Product Change Notification

1. ECN #: 265742

- TFC - .050 X .050 TERMINAL STRIP

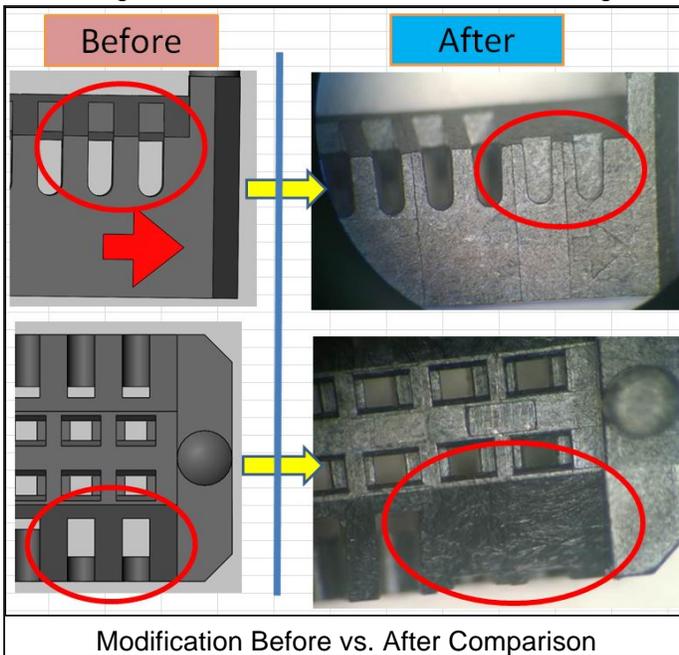
The voids in the keying notch location are being changed from visible/through to blind/filled.

The change to the void can be seen when viewing the connector body with no magnification needed.

The existing mold has a shut off condition that yields flash in the void during the molding cycle. By removing the voids, this condition is eliminated.

- Form - The voids at the keying notch location are being removed.
